SUBJECT: INSPECTION REPORT NO. 70-1151/2006-203

Licensee: Westinghouse Electric Company

Inspection Dates: August 28 - September 1, 2006

**Westinghouse Electric Company
NRC Inspection Report No. 70-1151/2006-203**

Figure 1

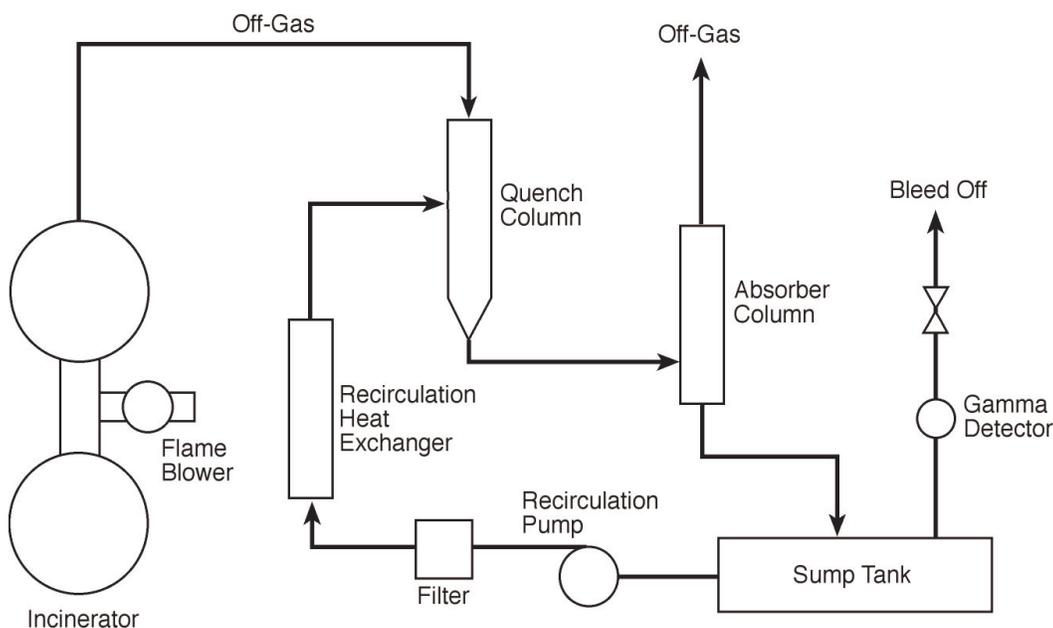
The inspectors reviewed the licensee investigation of a blower fire in the recently restarted incinerator. The inspectors noted that discharge from the quench sump tank was interrupted when uranium content increased beyond discharge limits resulting in an increase in water level in the absorber tanks until the incinerator off-gas ceased to flow through the quench tanks. As a result of increased system pressure, off-gas leaked through the flame blower and caused a fire in the flame blower filter. The incinerator quench system is illustrated in Figure 1.

The licensee proposes to correct the problem by redirecting the sump discharge through the quench recirculation line filter to reduce contamination levels at discharge. The licensee investigation was not complete at the time of the inspection. The inspectors did not identify any safety concerns during review of the flame blower fire. Because the incinerator quench system is a key component of the criticality safety basis for the incinerator, corrective actions for the incinerator flame blower fire will be tracked as **Inspection Follow-up Item (IFI) 70-1151/2006-203-01**.
